# DART SERVICE INSTRUCTION

TO AMEND INSTALLATION INSTRUCTIONS IIN-D412-742-2 REV.A OR LATER APPROVED REVISIONS AND INSTRUCTIONS FOR CONTINUED AIRWORTHINESS ICA-D412-742-2 REV.0 OR LATER APPROVED REVISIONS

REF. FAA STC:SR01583SE

Wearplates D5489-041, D5489-3, and D5489-045 on D412-742-021/-023 Float Skidtube Installations have been modified @CHG 002 to improve durability. The new wearplate design features two additional tabs attached to the saddle, and narrower slots to prevent shifting.

FIGURE 1 - SADDLE INSTALLATION

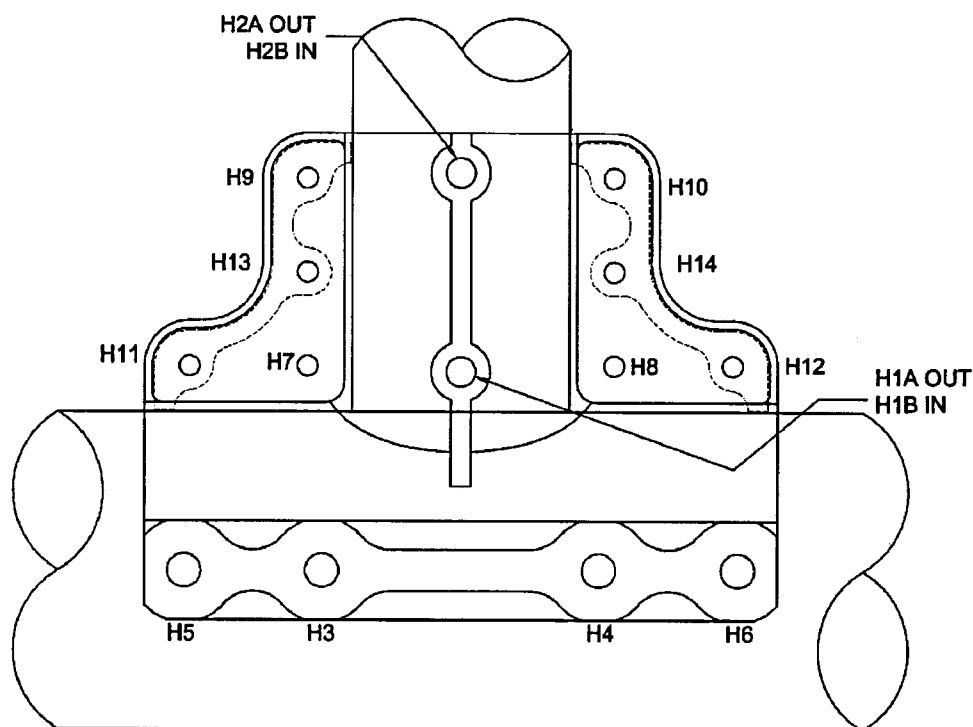
- 2.1.1 Hoist or jack the helicopter using the procedures prescribed in the Aircraft Maintenance Manual. Disconnect/remove and retain any clamps/fittings/hoses/float bags associated with the float system that will interfere with the removal of the wearplates. If installed, remove the D412-742-028 Cable Guard per section 32.8 of ICA-D412-742-2.
- 2.1.2 Remove D5489-041, D5489-3, and D5489-045 wearplates by removing AN3 bolts, D5513-1 bushings and MS21043L3 nuts. Retain D5513-1 bushings.
- 2.1.3 Check skidtube for corrosion and mechanical damage in accordance with chapter 5.3.1 of ICA-D412-742-2 and repair as required.
- 2.1.4 Remove AN4 bolts, D5446-1 bushings and MS21043-4 nuts at saddle holes H3 and H4 as shown in Figure 1 of this Service Instruction. Retain D5446-1 bushings.

**Notes:** Saddle bolts H3 and H4 are AN4C53A per Parts List in Section 5.0 of this Service Instruction.

**FIGURE 2 - D412-742-021 FLOAT SKIDTUBE INSTALLATION**  
(OEM/PMA FLOAT COMPATIBLE)

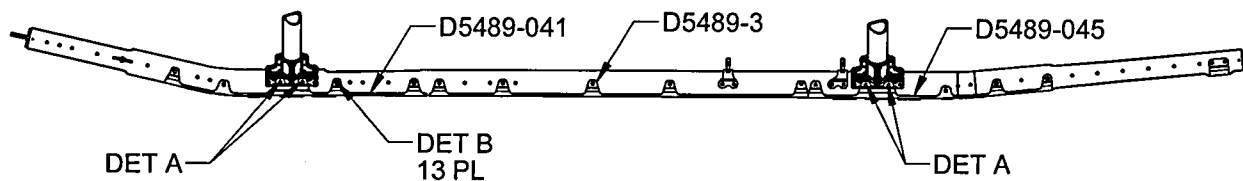
- 2.1.5 Loosely attach new D5489-041, D5489-3, and D5489-045 wearplates to the skidtube as shown in Figure 2 and Figure 3 using AN3 bolts, D5513-1 bushings and MS21043-3 nuts as shown in Detail B. Ensure that nuts on the bolts are on the inboard side of the skidtube.

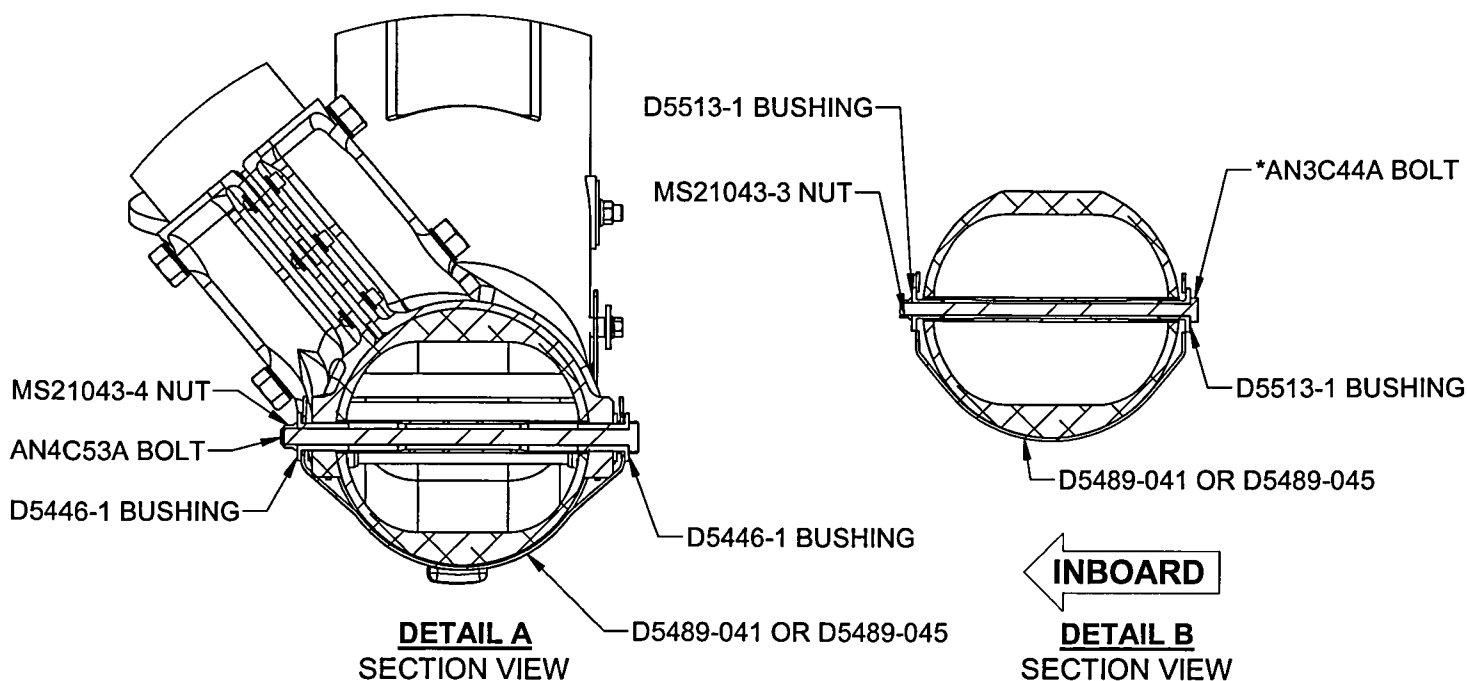
- 2.1.6 Loosely attach AN4C53A bolts, D5446-1 bushings and MS21043-4 nuts as shown in Detail A.
- 2.1.7 Clamp D5489-041, D5489-3, and D5489-045 wearplates firmly to the skidtube leaving no gaps.

\* USE AN3C46A BOLT WHEN ALSO SECURING THE GIRT AT THE BOLT ATTACHMENT
